Westinghouse  
Electric Corporation

NSD-NRC-97-5187  
DCP/NRC0917  
Docket No.: STN-52-003

SUBJECT: RAI RESPONSES RELATED TO AP600 CERTIFIED DESIGN MATERIAL

## RESPONSES TO NRC REQUEST FOR ADDITIONAL INFORMATION

### 1.8 Interfaces for Standard Design

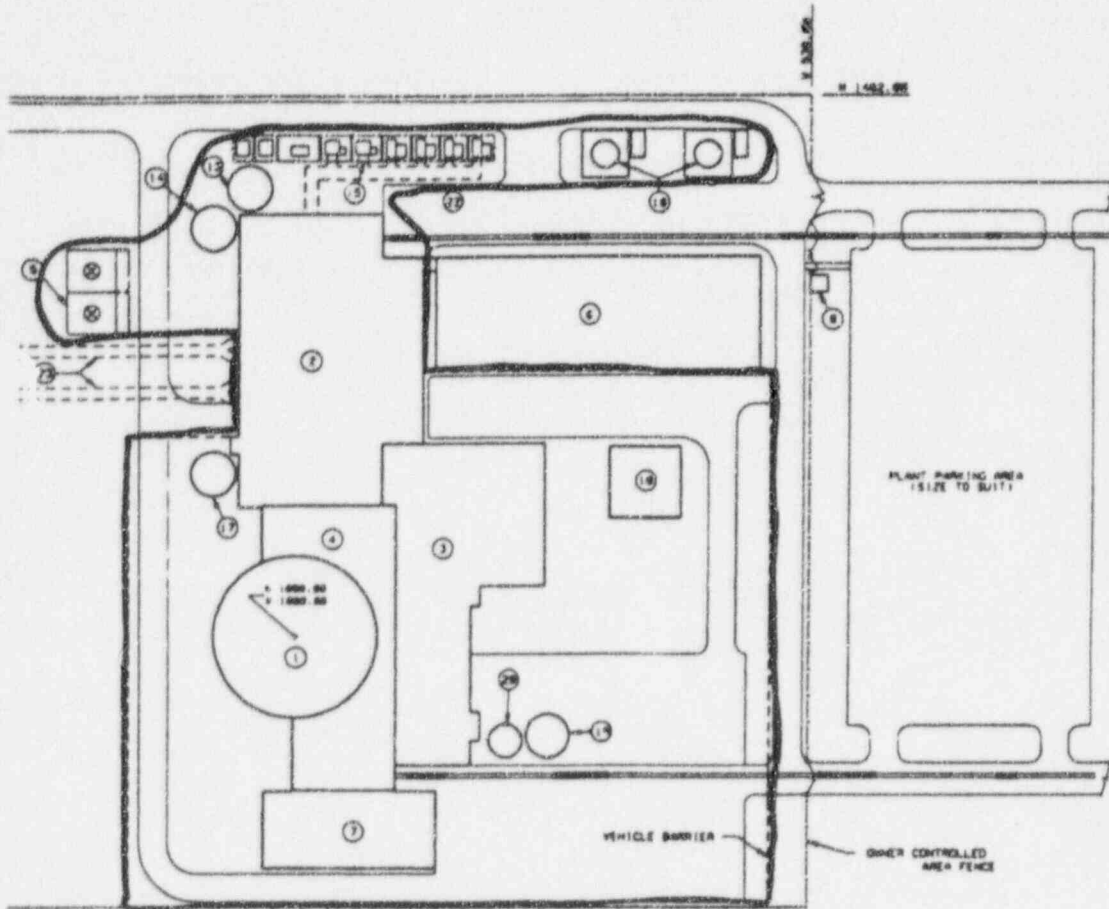
Chapter 1 of the SSAR and the CDM do not show what the boundary is for the AP600 design scope (even Figure 1.2-2 is unclear). In order to meet the requirements of 10 CFR 52.47(b)(1), Westinghouse needs to identify the structures and systems that are wholly or partially outside (or inside) the scope of the design to be certified and specify the boundary of the certified design scope (see SRP 14.3, page 30 for guidance). For example, it appears that the following structures are in the AP600 scope:

As stated in Section 1.8 of the AP600 SSAR, the AP600 plant design included in the application for Design Certification incorporates the entire Nuclear Island, the annex building, the diesel/generator building, the turbine building, the radwaste building, and their associated equipment, associated yard structures, and security structures. A SSAR change is included below to clarify this boundary definition.

The AP600 is a plant design incorporating the entire nuclear island, the annex buildings and associated equipment, the diesel/generator building and associated equipment, the turbine generator building, the turbine/generator equipment and the radwaste facilities. The physical boundary of the portion of the AP600 design included in this application for Design Certification is shown on the site plan, Figure 1.2-2. It includes arrangement and placement of structures within the indicated boundary including the vehicle barriers necessary for security, but not the boundary fence. As a result, no interfaces need to be identified between or among these portions of the plant. They are addressed in their appropriate section of this SSAR. There are, however, a number of safety-related informational, administrative or operational interfaces between the AP600 design and other portions of a completely licensed facility which must be addressed by parties that reference the AP600 design. These interfaces are identified in Table 1.8-1 in the order they are presented in this SSAR.
